SERVICE BULLETIN

Number: SB0302

Subject: Weight Kit for New Design Z42 and Z48

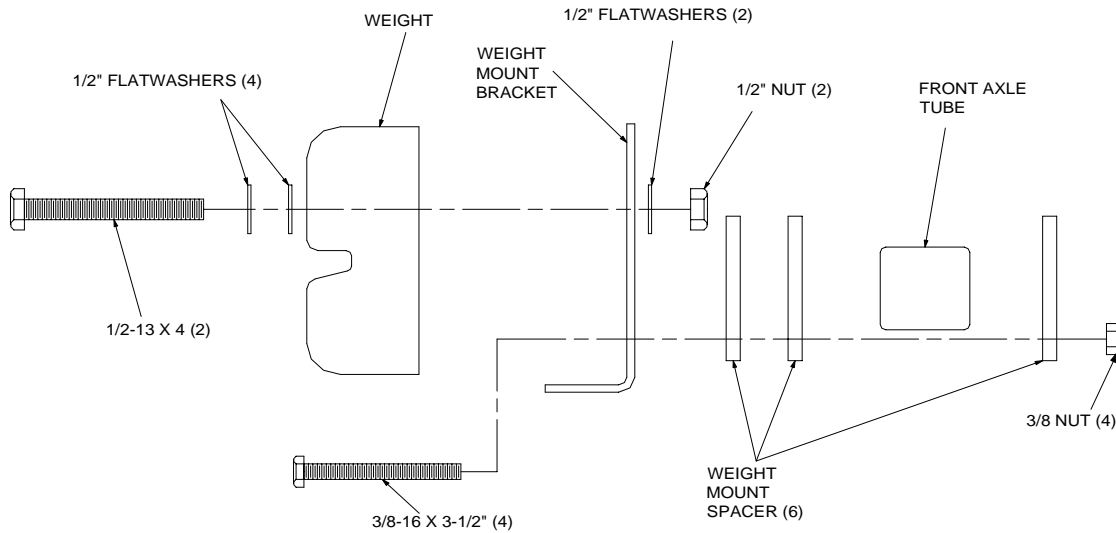
The new design Z42's and Z48's now have rigid front axles (non-articulating). Therefore, when installing the front weight kit in conjunction with the Z-Rider Grass Catcher, you will need to order **weight bracket kit, part # 522169, and weight kit, part # 821017.**

This change affects Z42's and Z48's with serial # 43664 and above.

- 1) Using the 3/8x3 1/2 HHCS, bolt together the weight mount bracket (part # 523502) and weight mount spacers (part # 523504) onto the front axle as shown in diagram.
- 2) Place weight (part # 823281) onto weight mount bracket and secure into place using 1/2x4 HHCS, 1/2 Std Flat Washers, and 1/2 Nyloc Nut as shown in diagram.
